ATR on Quality Control Check Report. (Apartments)

MAYFLOWER PLATINUM

Details of Additions & Alterations

Flat No	802	Block no.	'A'
Flat Area	1500 sft	Type	Deluxe / Luxury
Buyer Name	P Vikas Harsha/P Sheetal Mohan das		
Phone No.	9581030003/9533335333	Email

Description		Direction	Owners & Developers :		Date :	Promoted by	
PLUMBING PLAN OF A2		N	Modi Properties Pvt. Ltd.		09.01.2020	Modi Properties & Investments Pvt. Ltd.	
			Project Name & Phase :		Prepared By :		
			Mayflower Platinum		Approved B		
			Scale :		N.T.S		
						Phone: +91-40-66335551

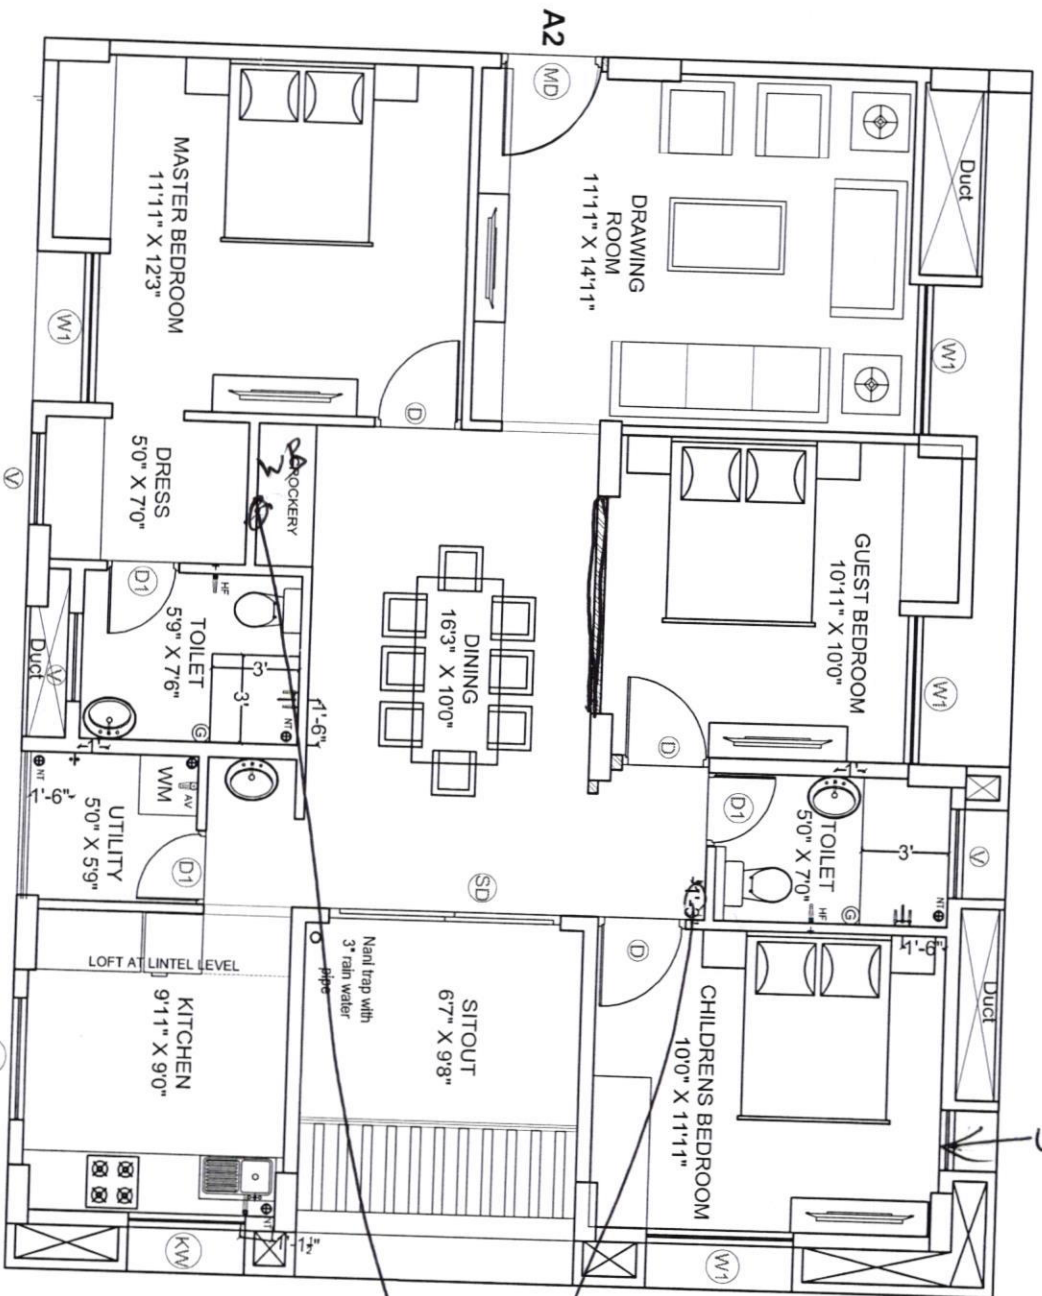
Changes in kitchen platform: (mark on plan)

- 1) Platform not required.
- 2) Sink not required
- 3) Grill for Utility not required
- 4) Door frame by Door not required for utility.

- 1) G.B.R. Brickwork cover over side 4" level of Dining Place. (Marked on plan)
- Cancelled.

ELECTRICAL PLAN OF FLAT-A2

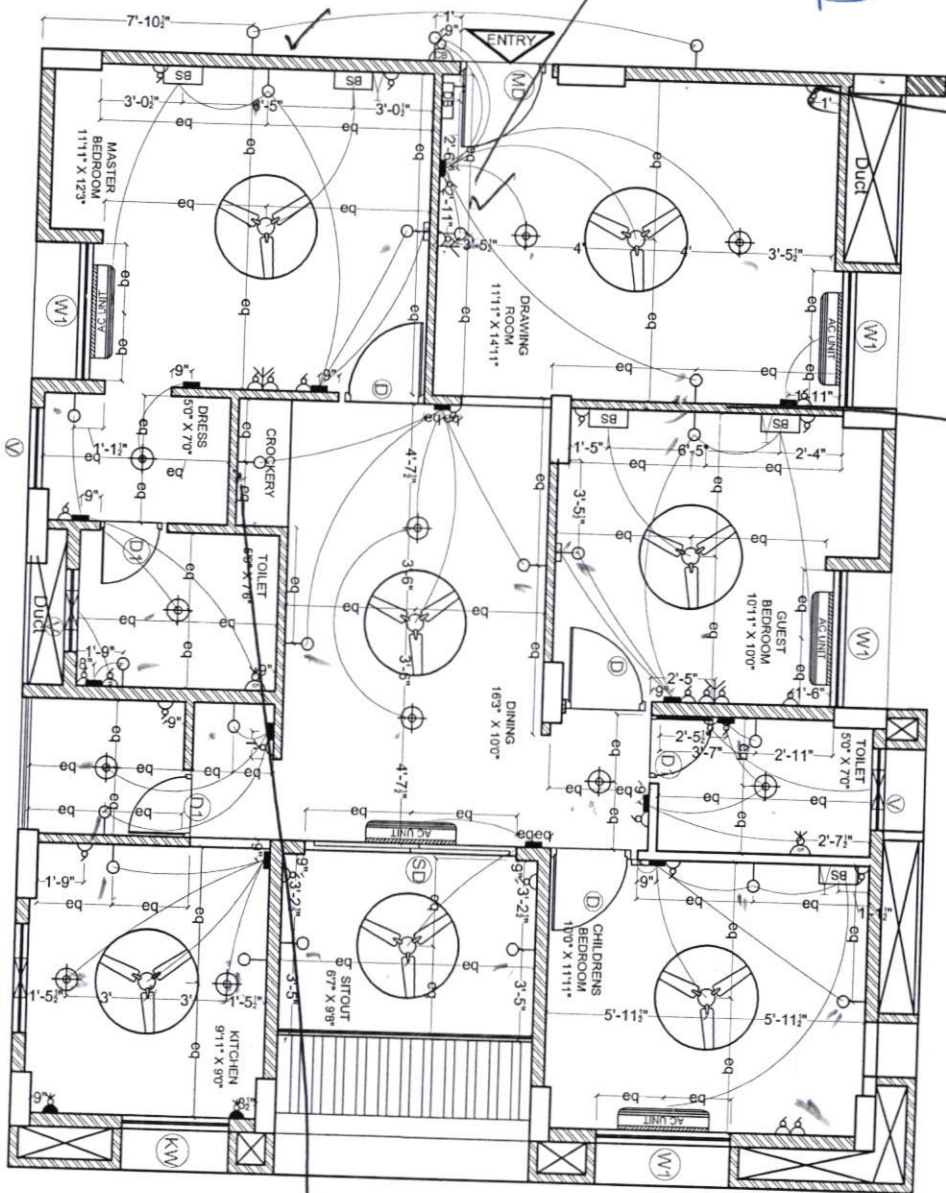
Changes in electrical points: (mark on plan)

- ① Every wall extra 15amp plug point
- ② All pts marked on plan.
- ③ Switch boards & switches not required. will be brought by us.

WORKING DRAWING OF FLAT.NO.A-2

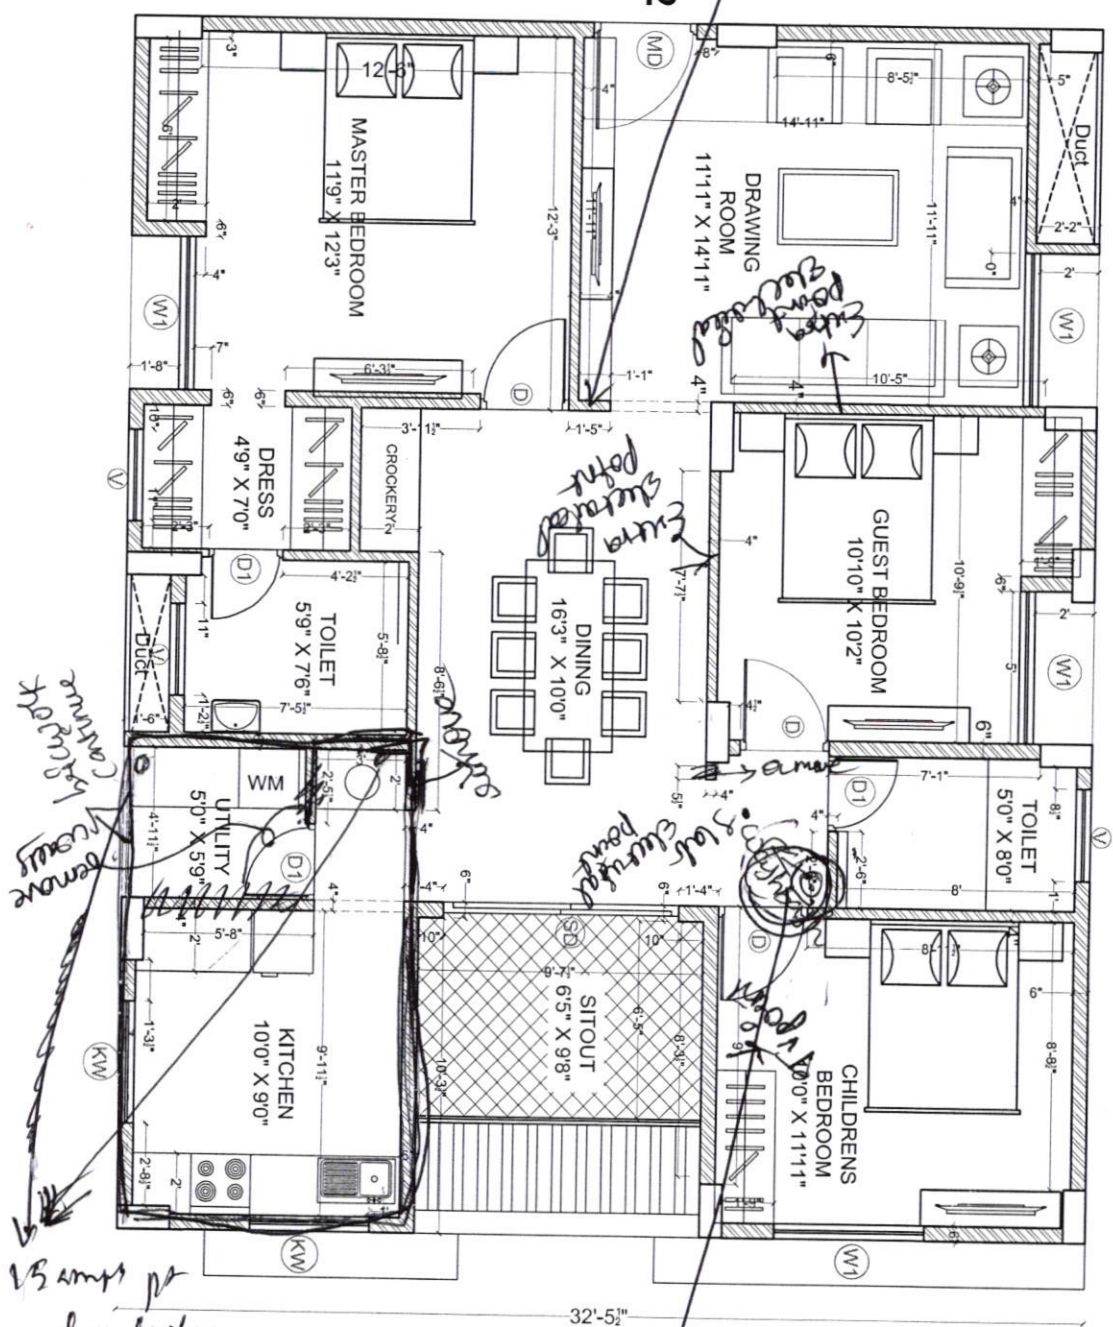
to be removed
